## Deadline 8 – Summary of Position

File Ref: P21-2319

Subject: **Fordley Hall – Deadline 8 Submission**

**Figure 2.1 – CadnaA model and proposed barriers**

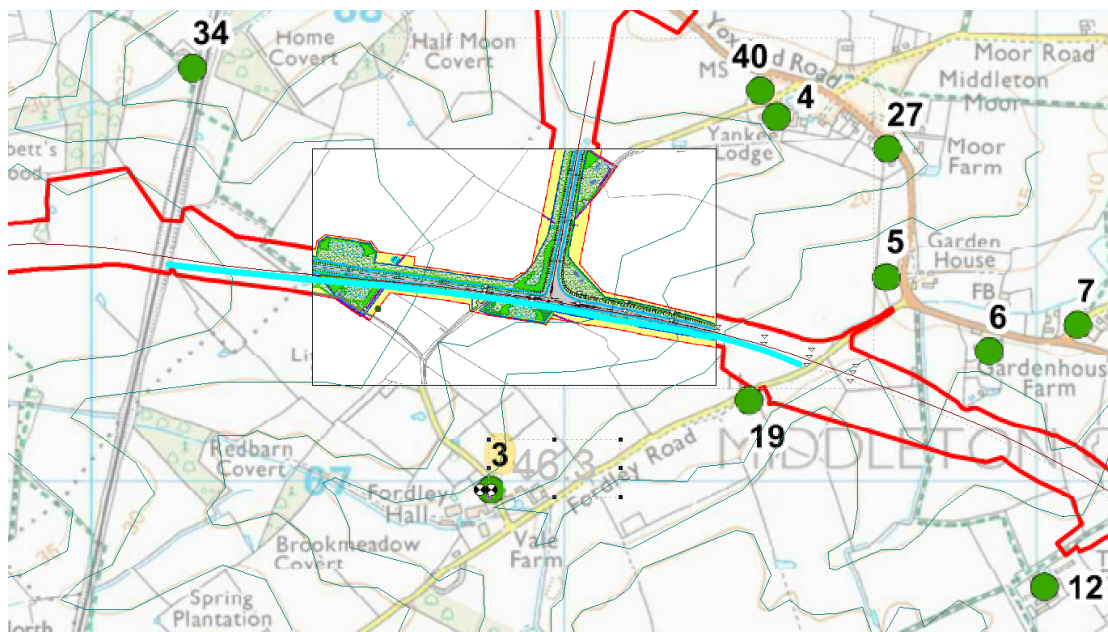
- 2.14 Create have carried out some preliminary calculations, using 3D noise propagation software, CadnaA to assess the positive impact that a 3 m high barrier/earth bund/combination, would have on Fordley Hall.

- 2.15 CadnaA uses the most relevant methodology (works to ISO 9613-2 using CRTN methodology).
- 2.16 The model and the proposed barrier locations are shown in Figure 2.1. to reduce noise from the link road the barrier should be located as close as possible to the road and run continuously alongside it where possible. The proposed barrier location has been shown in blue.

- 2.17 Calculations have shown that a 3-metre-high barrier would provide approximately 3 dB attenuation to the first-floor windows of Fordley Hall. Using the predicted ambient noise levels from Table 4.14 of the main Noise and Vibration Chapter (Volume 6 Chapter 4 Noise and Vibration) this would reduce the ambient sound level from the SLR **without Sizewell C construction** traffic to 32 dB  $L_{Aeq,16h}$ .

- 2.18 By applying the same 3 dB attenuation, the sound levels for a typical day during the **peak construction year** (using the data from Table 4.18 of Chapter 4) would be 46 dB  $L_{A10,18h}$  and 39 dB  $L_{night}$ , including the 3 dB attenuation provided by the barrier. This would increase slightly for the busiest day in the peak construction year to 47 dB  $L_{A10,18h}$ .

- 2.19 Applying the same 3 dB attenuation to the sound levels provided by the Applicant in Table 4.15 from Chapter 4 Noise and Vibration, the sound levels have been reported to be at 54 dB  $L_{Aeq,T}$  (reported 57 dB minus 3 dB) for the main construction phase of the SLR.

OPTION A - EXISTING ROAD LEVELS MAINTAINED AND STRUCTURE BUILT OVER FORDLEY ROAD

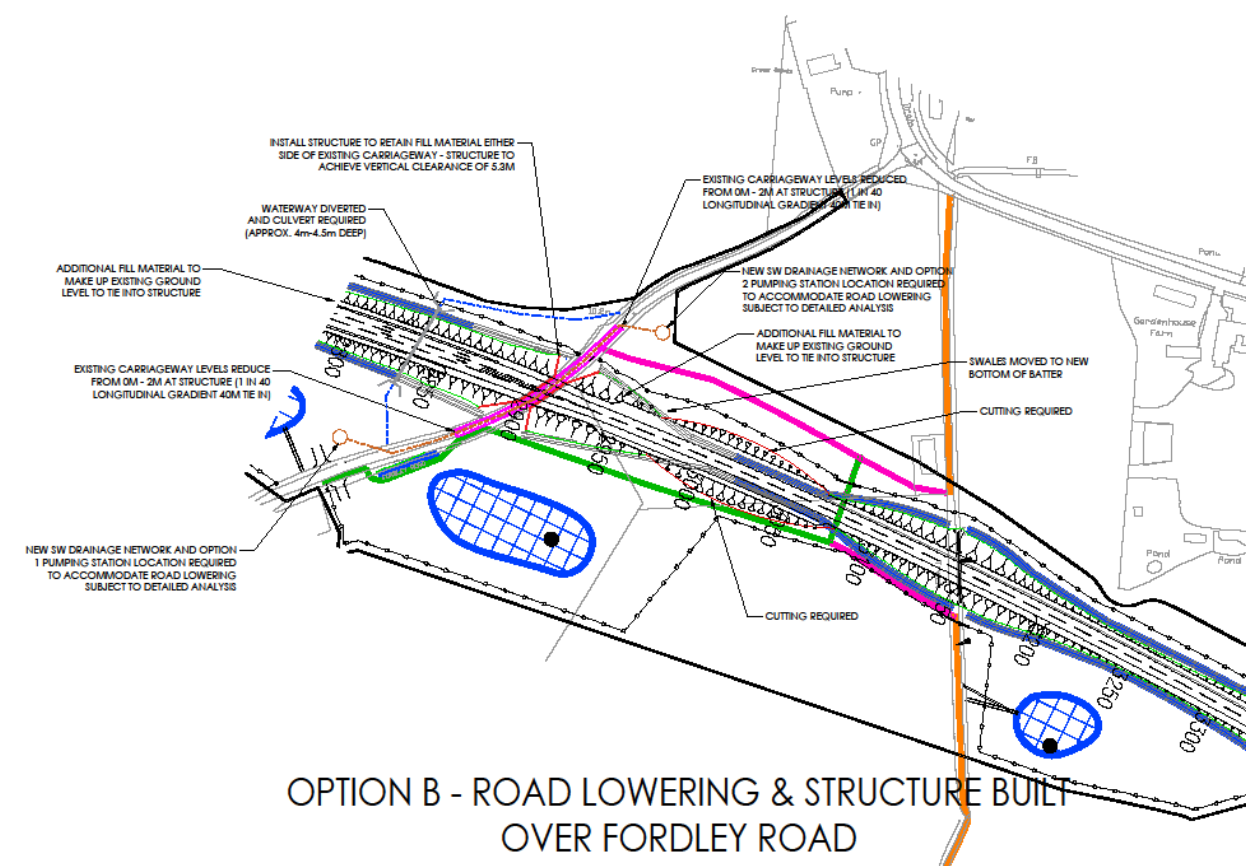
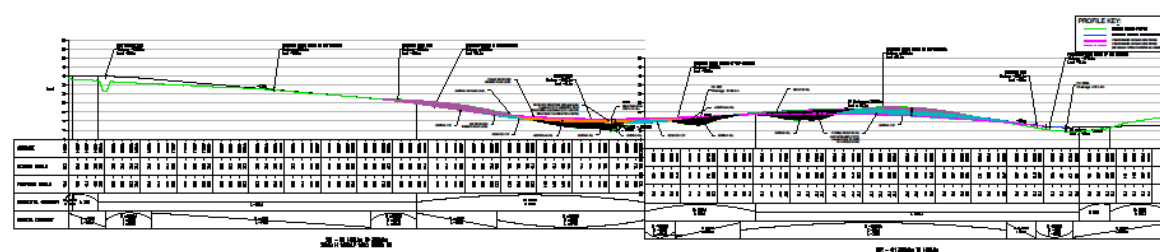
***Create Consulting Engineers' Option A suggestion to provide the SLR crossing over Fordley Road (retained at its current level) with a minimum clearance of 5.3m to the underside of the SLR shows the Project longsection alignment lifted some 3.5m. The SLR is already on a 3.5m high embankment thereby the alignment suggested is over 7m in height at Fordley Road. An increase in embankment height of this magnitude at this location is considered a severe impact on the landscape and an unacceptable detrimental impact on the adjacent Vale Cottage properties.***

***The Create Consulting Engineers' Option A plan layout shows an underpass at SLR chainage 2900 and the long section shows it at chainage 2850. This is assumed to be an error and the underpass on the long section should also be at chainage 2900 which would change the vertical alignment suggested as a result. The long section underpass position would therefore need to move eastwards to match the plan position.***

***The Create Consulting Engineers' suggested vertical road profile is shown to dip either side of the underpass location which would reduce driver visibility and introduce a safety concern with vehicles being partly hidden in the dip. The Suffolk County Council highway design standards vertical curvature and site stopping distances for the dipped sections is below the requirements of a 60 mph speed limit and would therefore not likely be an acceptable safe design to the highway authority. The Create Consulting Engineers' Option A is therefore also rejected on highway design safety considerations.***

***For Option A, a wider underpass to span the watercourse and Fordley Road would therefore be required and as a result increase the size and thickness of structure thereby requiring the road alignment to be raised further and increase the embankment widths. A profile to eliminate the dipped sections, alter the underpass position and level, and provide sufficient longitudinal gradient for surface drainage would require the alignment to be lifted for a longer length to that suggested by the Create Consulting Engineers' Option A. This revised option would increase the Project's SLR alignment levels by approximately 4m to create an over-bridge with sufficient clearance to Fordley Road (5.3m). The SLR would already be on an embankment of up to 3.5m, so this arrangement would require a substantial increase in land area required for embankments at Fordley Road.***

***The engineering required to achieve this would result in a 480m long higher embankment to the east of Fordley Road up to 10m wider to the north and 6m wider to the south. To the west, the embankment would be higher for a length of 400m up to 10m wider to the north and 7m wider to the south before the vertical alignment could tie in to the current design height.***

- 3.3 Create have reviewed and revised Option A , this is provided in Appendix A.
- 3.4 The height above Fordley Road is reduced to demonstrate a reduced impact on the adjacent property. The vertical height required is close to the elevated topography to the east, which could be graded into the existing landscape. Option A also omits the need to cut into the

3.5 Create have revised Option A.

3.6 This reduces the previous amount of fill that may be required. Note that your location of CU001A appears to be overlaid over the existing watercourse on the long section which differs to the layout plan for the watercourse diversion.

3.7 In the updated Option A the vertical road profile mitigates any dipped sections to generate a vertical curvature that would be acceptable to Suffolk County Council and have an acceptable visibility, this is considered acceptable and viable.

- 3.12 There would only need to be 70m increased filling directly to the east of the structure in the revised plans. A further filling of 200m long but on average 0.75m depth would be required

between CH3025 to CH3225. The revised Option A however reduces the fill required between CH3225 and CH3575 (approx. 250m) by on average 0.5m depth.

- 3.14 Analysing the areas beneath the Option A proposed levels, a 22% increase in fill material is required east of Fordley Road.
- 3.15 To the west a filling of on average 2.3m deep between CH2900 and CH2650 (circa 250m) which would likely involve increasing widths of embankments (if at 1in3 gradient) approximately by 7m either side of the SLR. It is likely that this increased footprint could be achieved within the development boundary.

- 3.16 Analysing the area beneath the Option A proposed levels, the fill volume would likely be doubled to the west of Fordley Road to achieve clearance over the structure and maintain good visibility through vertical curvature.

- 3.17 Create have suggested a secondary alignment between CH3300 to CH4100 (shown by dashed lined) which could be explored to generate the additional fill material required to the west of Fordley Road to balance the cut and fill in the vicinity of the structure. This would promote reduced HGV moments for fill materials providing increased sustainability.

OPTION B - INDICATIVE LONG SECTION

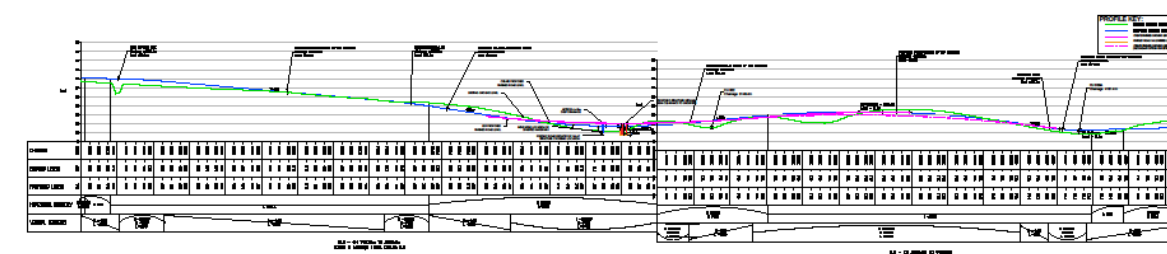
***The Create Consulting Engineers' Option B suggestion of lowering Fordley Road beneath the SLR with a proposed pumping station was considered but would create a significant localised depression in the landscape which would result in an increased risk of flooding of the road, noting that the Middleton Drain watercourse running alongside Fordley Road is the responsibility of the Environment Agency.***

***The clearance from Fordley Road to the underside of the SLR bridge is shown at Option B at a minimum of 5.3m which would cause a significant depression. Fordley Road would also need to be lowered some 3m over a reasonable distance to meet road design standards. To create the required depression for Option B, the lowered Fordley Road would require a cutting embankment in excess of 200m in length and some 7.5m high to the east at a width of up to 22m, and a cutting embankment 3.5m deep to the west at a width of up to 11m.***

***The watercourse would require diverting. The extent of embankment cutting to lower Fordley Road and divert the watercourse would not reduce the land area required compared to the provision of a T-junction and turning head in the Project submission and thereby provides no benefit to reduce land area. The impact of lowering Fordley Road and the surrounding landscape to this extent would increase the required agricultural land area to the north of the SLR Crossing for the reprofiling of Fordley Road and to provide a sufficient grade for the PROW diversion and maintenance access to the attenuation basins to the east.***

***Option B indicates flood water would need to be pumped back out of the underpass. However, the sketch shows this being taken to the upstream side of the SLR and discharges upstream to flow through the culverted section of the diverted channel downstream. In addition, it is expected that Suffolk County Council Lead Local Flood Authority may ask that this is restricted and discharged at a greenfield rate, leading to the need to attenuate and store the water temporarily. Therefore, to create a depression and pump the fluvial flows suggested by the Create Consulting Engineers in Option B is considered to be unacceptable and would likely be strongly opposed by the Environment Agency. In addition, as the pumping drainage approach is less sustainable it would be unlikely to receive support from Suffolk County Council as Lead Local Flood Authority.***

- 3.21 Option B has been revised (similarly to Option A) with the structure repositioned on the long section and provided in Appendix B.

- 3.22 The revised Option B plans demonstrate that a combination of road lowering and increasing the height of the SLR could be achieved. Fordley Road could be reduced by 1m which would mean only a 1.6m height increase to the SLR. This in turn reduces materials required to build up adjacent SLR embankments east and west of Fordley Road.

- 3.23 Since the lowering is only by 1m, the previous Option B suggested 200m length can be halved. The watercourse would need to be diverted similarly to the detail for the current EDF proposals and a drainage network would need to be installed for the 100m section of Fordley Road to be lowered. With the removal of the T-Junction, the cost balance between the road lowering and associated drainage would likely financially balance that of the T junction construction being removed.

- 3.26 The drainage proposal demonstrates an option to remove surface runoff from within the structure and road lowering, it would likely need to be pumped but is not insurmountable.

- 3.27 Option B reduces additional materials and gives a secondary option to generate more fill material after CH3300 and up to CH4100 to balance the cut and fill. The option demonstrates that surface water runoff could be managed subject to further analysis and utilises the current watercourse measures suggested by EDF.
